# Assessment report to Sydney Central City Planning Panel

Panel reference: PPSSCC-271

<b>DA number</b>	SPP-21-00008	<b>Date of lodgement</b>	24 June 2021
<b>Applicant</b>	Alan Goh		
<b>Owner</b>	Perpetual Trustee Company Ltd		
<b>Proposed development</b>	Demolition of existing buildings and hardstand areas, and tree removal. Construction of 3 warehouse buildings and distribution facilities with a total of 10 tenancies and ancillary offices, landscaping, signage and car parking.		
<b>Street address</b>	201 Power Street, Glendenning		
<b>Notification period</b>	23 July to 6 August 2021	<b>Number of submissions</b>	0

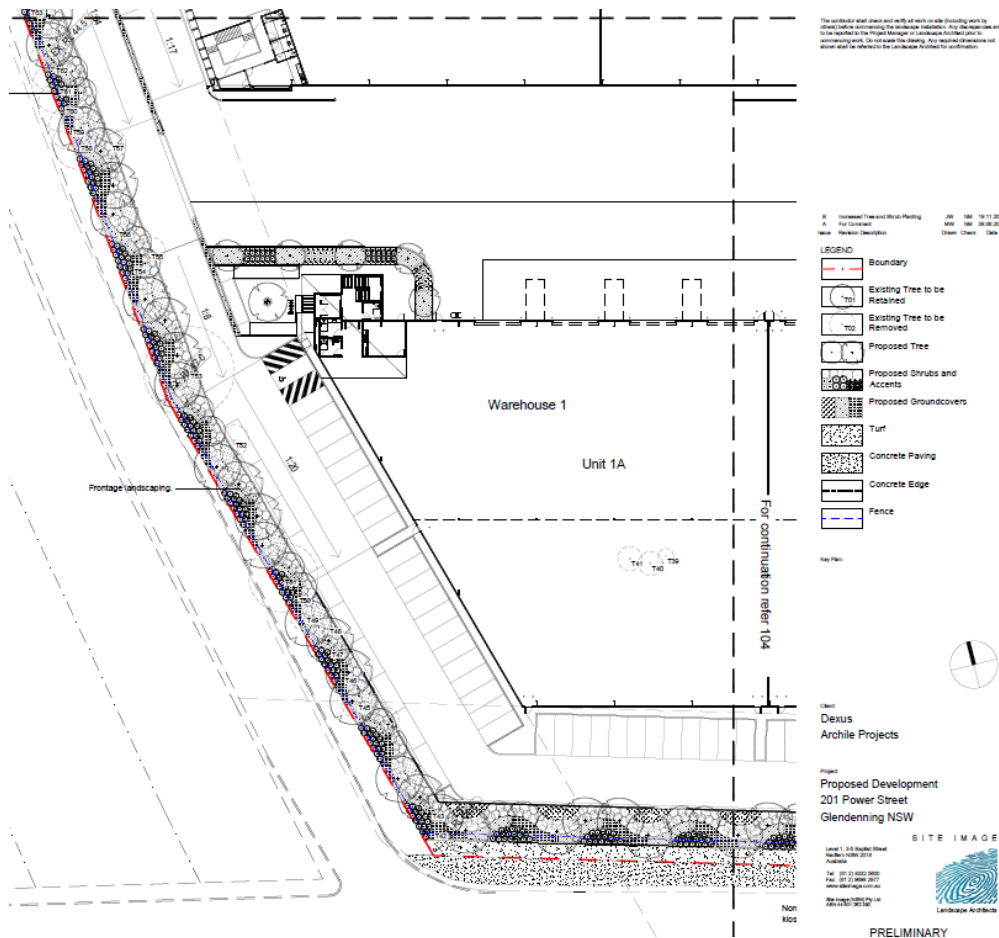
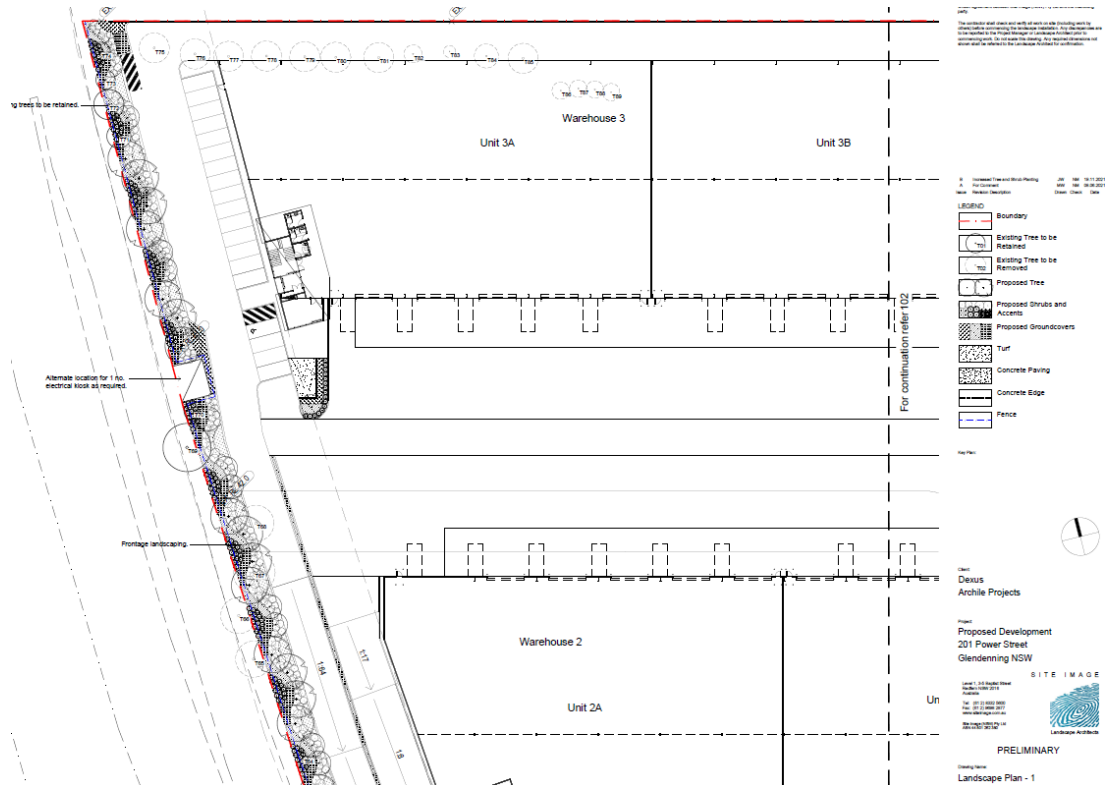
- 8.1.2 The Panel requested further screening for retaining walls and warehouses.

- the amended landscaping plans and additional tree planting within setbacks adjacent to the 2 street frontages will reduce the visibility of both the retaining walls and warehouses

- the photomontages and extracts from the landscape plans provided below illustrate how the landscaping will screen and soften the built form of the development as seen from the M7 motorway and Power Street

- the proposal will provide a densely vegetated 7.4 m landscaped setback to Power Street, which is above average for the portion of Power Street between the M7 motorway and Glendenning Road. The Power Street frontage has been embellished with further vegetation as well as provision for street trees within the public domain

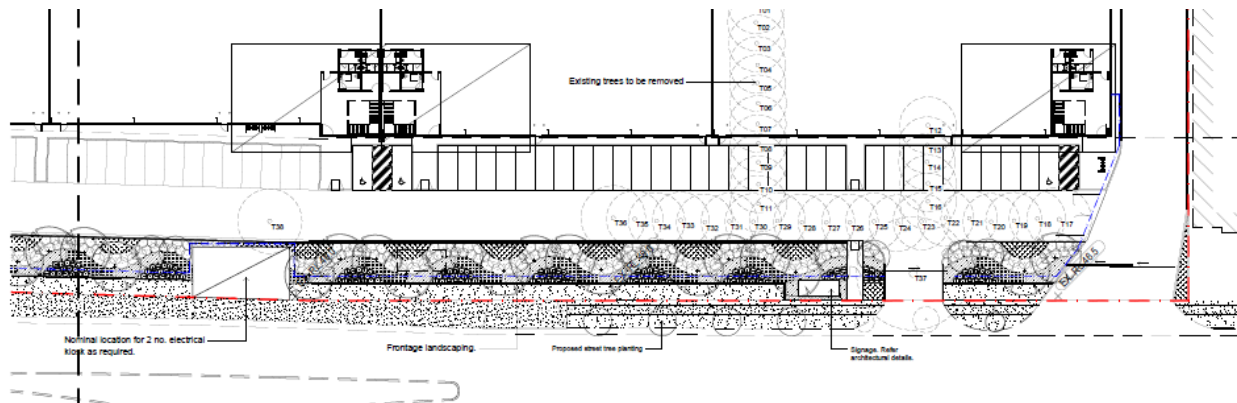
- the highest retaining wall (with a height of 3.3 m) that will be publicly visible faces towards the M7 motorway. It will be located adjacent to Warehouse 2's western façade. The bottom of this wall is located below the existing level of the M7 which will reduce its visibility. Visibility of the wall will be further reduced by the offramp of the M7 which elevates to Power Street as this wall is mostly located behind the offramp.

Notwithstanding the last point above, we propose to include a condition of consent requiring the submission of an additional landscape plan prior to the issue of a Construction Certificate that illustrates either an up-creeping or down-cascading landscape treatment feature to the satisfaction of the Principal Certifying Authority to further screen and soften this retaining wall.
